**BEFORE THE BOARD OF PATENT APPEALS
AND INTERFERENCES**

Application Number: 10/537,032
Filing Date: November 14, 2005
Appellant(s): MILLER, FRANK

EXAMINER'S ANSWER

Fig. 1

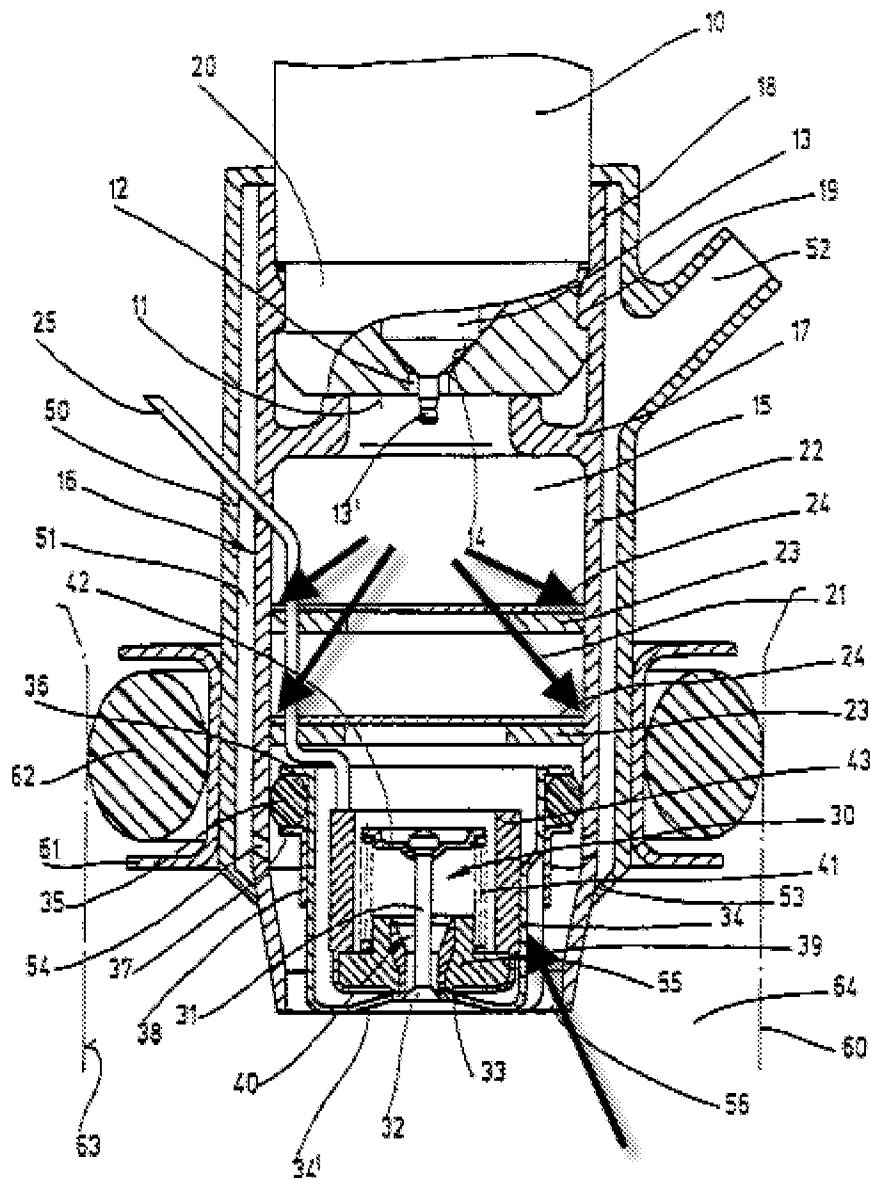
Krohn (see Figure 1) shows at least one metering device comprising a fuel injection valve (10), which meters fuel into a metering conduit (22); a nozzle body (33, 34, 35) adjoining the metering conduit, the nozzle body having at least one spray discharge opening (opened and closed by valve head member 32) which opens into a metering chamber (60); and at least one electrically operated heating element (23 and 43 in Figure 1, or 23' in Figure 2, or 23'' in Figure 3) with which heat can be delivered to the fuel, including at least one of a wire braid networked in mesh fashion, and a tubular hollow element. Krohn also shows an adapter (50) which joins the metering conduit and metering device in a hydraulically sealed and detachable fashion, the adapter including an air inlet (52; see column 4, lines 55-57) connected in the adapter to the metering conduit (via orifices 54). Krohn also shows at least one embodiment (see Figure 3) wherein at least one (centrally located heating element 23'') of the at least one heating element is immobilized using an attachment element (ceramic material in surrounding relation to centrally located heating element 23'') made of one of plastic, dip resin, or ceramic, and wherein at least

With respect to claim 14, Appellant first argues that the final Office action does not refer to any portion of Krohn et al. that discloses a heating element that delivers heat at least to a part of at least one of a metering conduit, an adapter, a metering device, and a nozzle body. As correctly indicated by Appellant, the Examiner has applied the element designated with reference number “22” to the recited “metering conduit”, reference number “50” to the recited “adapter”, reference number “10” to the recited “metering device”, and reference numbers “33, 34 and 35” to the recited “nozzle body”, all of which can clearly be seen in Figure 1 of Krohn et al.

In response to the above arguments, it is the Examiner's position that the claim 14 recitation, "wherein the heating element delivers heat at least to a part of at least one of the metering conduit, the adapter, the metering device, and the nozzle body" is clearly anticipated with the structure shown by Krohn et al., and such is further clearly and expressly disclosed within the reference to Krohn et al. As correctly referred to by Appellant in the appeal brief, the Examiner responded in the final Office action by citing column 5, lines 35-38 of Krohn et al., which states, "Depending on the shape of the injected fuel stream, some of the liquid fuel may also strike the inside surface of receptacle sleeve 22, where it is also evaporated if receptacle sleeve 22 is hot enough.". Appellant argues that this statement does not disclose any application of heat from the heating elements to the receptacle sleeve. The Examiner disagrees with this statement. As specified in column 5, lines 26-38, the heating elements "23, 23', 23" and 43" are the only elements which are capable of applying heat to the device shown in Figure 1. The passage cited above and in the final Office action by the Examiner states, in essence, that at least some of the fuel is evaporated by the "receptacle sleeve 22" (i.e. the metering conduit) if it is *hot enough*. Clearly, Krohn et al. is disclosing that the receptacle sleeve receives heat by saying "if receptacle sleeve 22 is hot enough". Thus, if the only heat applying elements of the device shown in Figure 1 are the heating elements "23, 23', 23" and 43", then it is clear that the heat received by the metering conduit 22 is transferred from at least one of the identified heating elements. Further, although the following additional response to the arguments was not set forth

by the Examiner in the final Office action, the Krohn et al. patent clearly and expressly discloses an additional teaching of a heating element delivering heat to at least a part of at least one of the recited elements of the claimed device. For instance, in column 5, lines 42-44, Krohn et al. states that the fuel is “additionally heated by heating element 43 and by outlet valve 30 which is *also heated by the heating element*”. As disclosed by Krohn et al. (see column 4, lines 18-29), the outlet valve is the broad combination element “30”, which includes the subcombination elements “33, 34 and 35” applied by the Examiner to anticipate the recited “nozzle body”. Thus, if the outlet valve 30 of Krohn et al. is heated by heating element 43, then the heating element 43 clearly delivers heat to at least a part of the nozzle body, which consists of the subcombination elements 33, 34 and 35, which partially make up the disclosed outlet valve 30.

Further, even if the disclosure of Krohn et al. did not expressly and clearly teach the delivery of heat to at least a part of at least one of the recited elements, based on what is shown by Krohn et al., it is clear that all of the heating elements “23, 23', 23" and 43” would apply at least some heat to at least a part of at least one, if not all, of the recited “metering conduit”, “adapter”, “metering device”, and “nozzle body” by convection and/or conduction. For instance, as can clearly be seen in Figure 1 of Krohn et al. (see locations indicated by the bold arrows below), heating elements “23” are in direct contact with the metering conduit “22”, and heating element “43” is in direct contact with portion “34” of the nozzle body. Thus, heat by at least conduction, would be applied to at least a part of at least the metering conduit and at least a part of at least the nozzle body through such direct contact.
